5. PUBLIC HEARING – SPECIAL USE AND PRELIMINARY SITE PLAN REVIEW (SU JPLN2021-001) - Proposed Panera Bread Café (with Drive Through), East side of Coolidge, south of Maple (1484 Coolidge), Section 32, Currently Zoned MR (Maple Road) District

SUBJECT: PUBLIC HEARING – SPECIAL USE AND PRELIMINARY SITE PLAN REVIEW (SU JPLN2021-001) - Proposed Panera Bread Cafe, East side of Coolidge, south of Maple (1484 Coolidge), Section 32, Currently Zoned MR (Maple Road) District

Preliminary Site Plan and Special Use Review For City of Troy, Michigan

Project Name: Panera-Coolidge
Plan Date: August 20, 2021
Location: 1484 Coolidge Highway
Zoning: MR, Maple Road
Action Requested: Site Plan and Special Use Approval

SITE PLAN

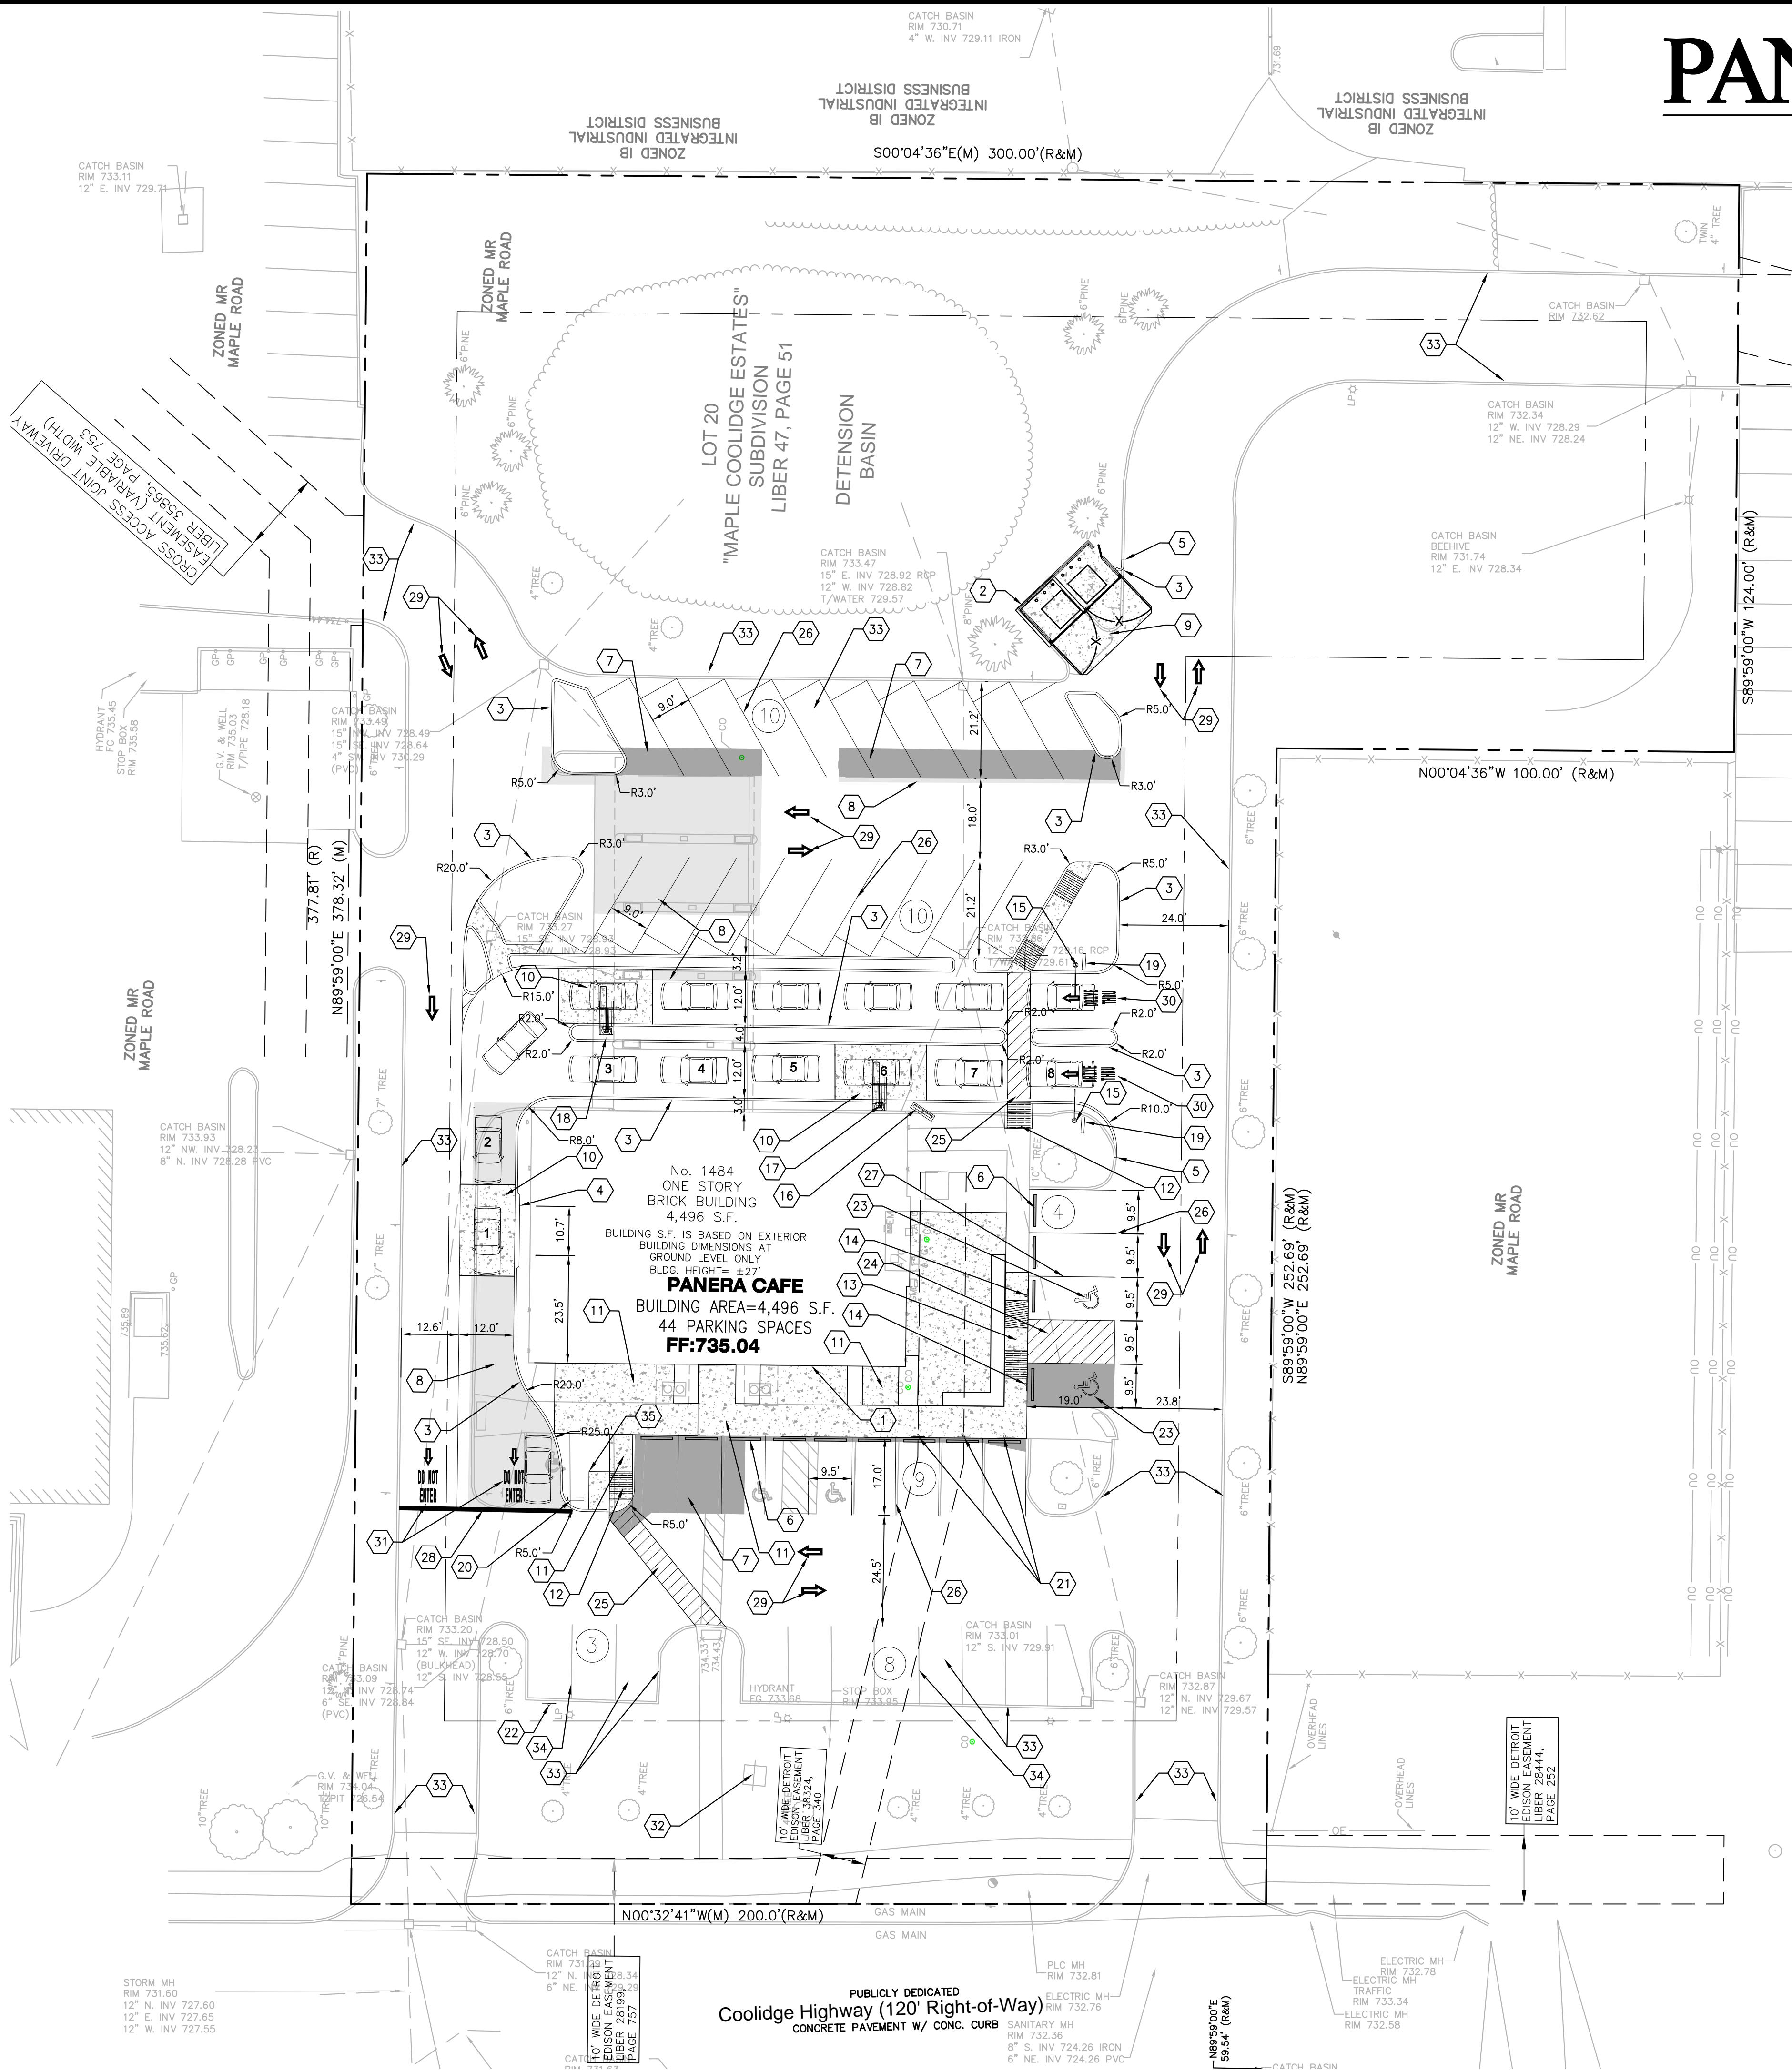
As noted, the building and parking location is non-conforming. The parking may remain but must be screened with screen wall adjacent to Coolidge Highway.

Items to be Addressed: Screen parking from Coolidge Highway.

- 1. The pedestrian crosswalk near the front of the building must cross the aisle near perpendicular. Reconfigure the pedestrian crossing to eliminate the skew.*

- 2. The layout and dimensions of the rear parking lot suggest this area would be intended for one-way traffic (northbound), however the traffic flow arrows indicate two-way circulation. The proposed 18-foot wide aisle is not sufficient to allow two-way traffic. Reconfigure or revise plans to reflect one-way flow, with appropriate pavement markings and signs.*

- 3. At the northwest corner of the site, the plans show a cross access easement with the two sites to the north. However, proposed cross access in this area is poorly configured, and both the existing and proposed cross-access fall outside this easement. As shown, access to/from the Rite-Aid site is awkward and would not be sufficient to allow vehicles to turn left from Rite-Aid. Reconfigure this area to maintain cross-access, with a drive aisle width of 24 feet.*

- 4. Eliminate the use of wheel stops along the south and west building faces. Instead, use raised concrete sidewalks to provide a vertical edge, separating parking spaces from pedestrian areas.*

- 5. On the south side of the building, widen the sidewalk to 7 feet and reduce the parking stall length to 17 feet. This allows for two (2) foot vehicle bumper overhang, while maintaining five (5) foot usable sidewalk width*

Applicant is deficient in loading space. Planning Commission may waive loading space based on evidence from the applicant that a loading space is unnecessary.

Items to be Addressed: Include loading space or seek waiver from Planning Commission.

Panera Bread
Site Layout
Troy, MI

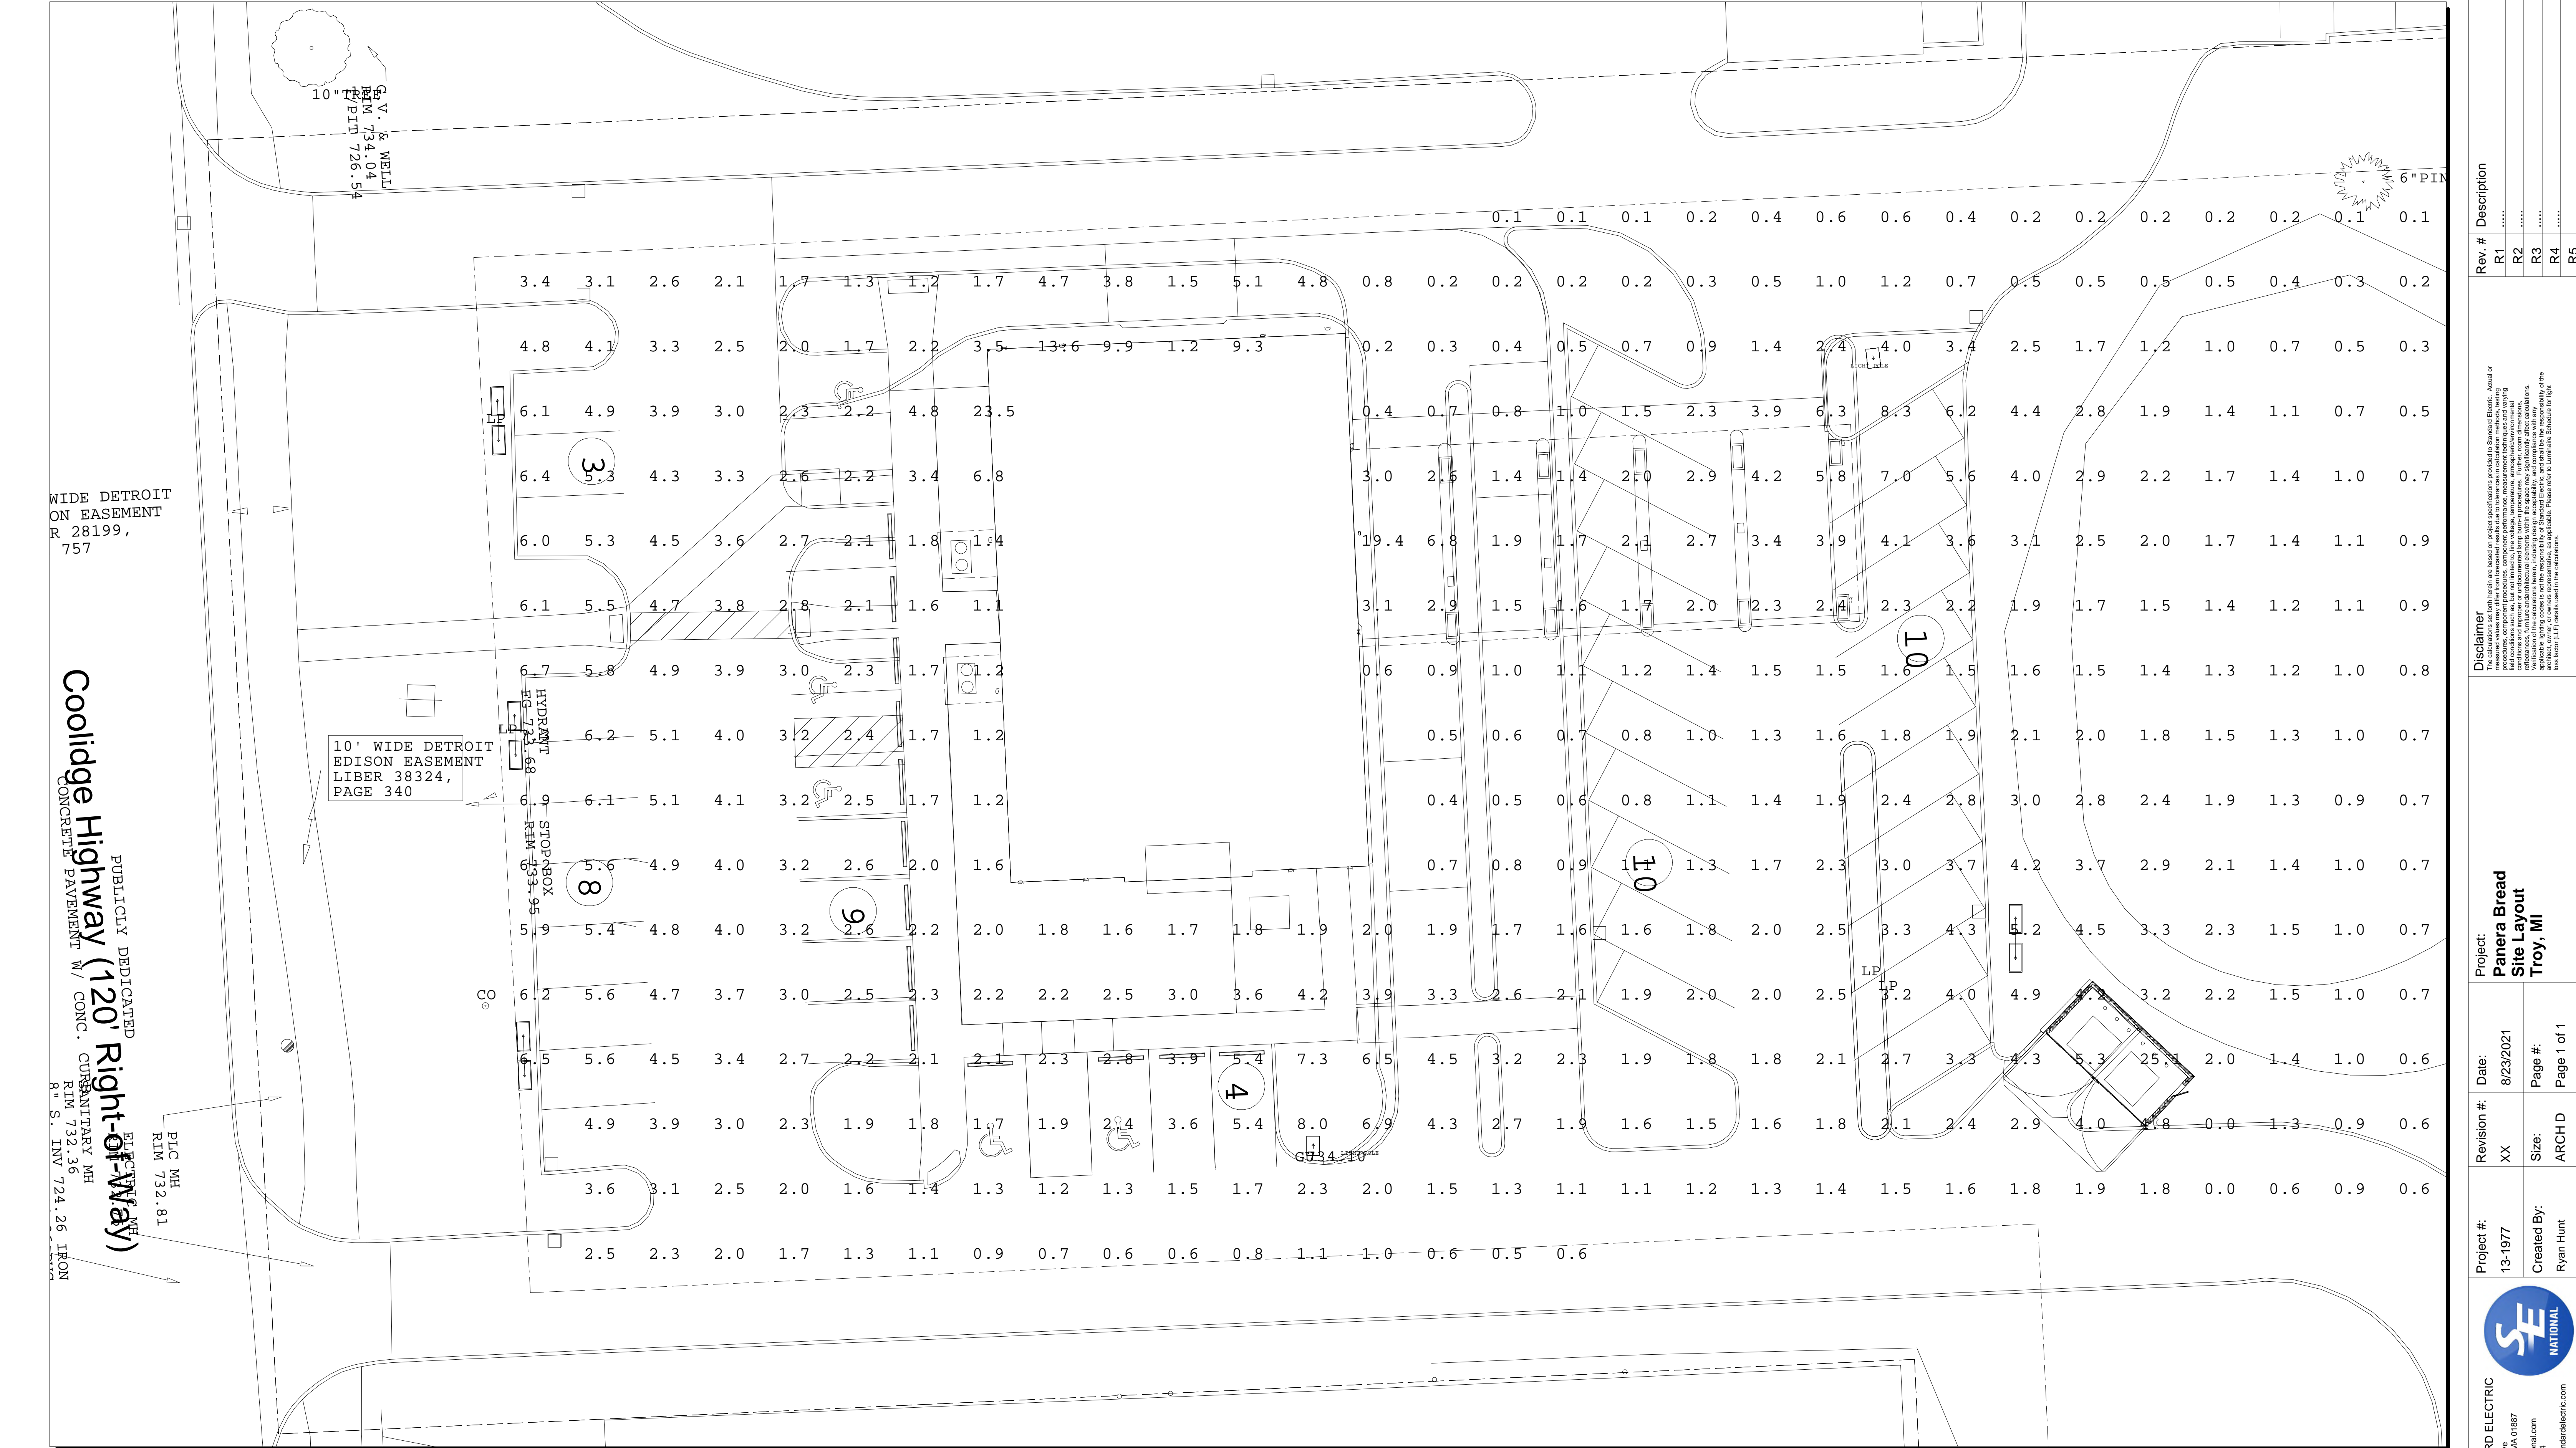
The applicant has provided a photometric. The plan is difficult to review because it appears the applicant is including both existing conditions and new improvements. In addition, the lighting levels exceed the

maximum along the south and north property lines. Lastly, the applicant did not provide lighting fixture cut sheets.

Items to be Addressed: Resubmit photometric plan and lighting fixture details.
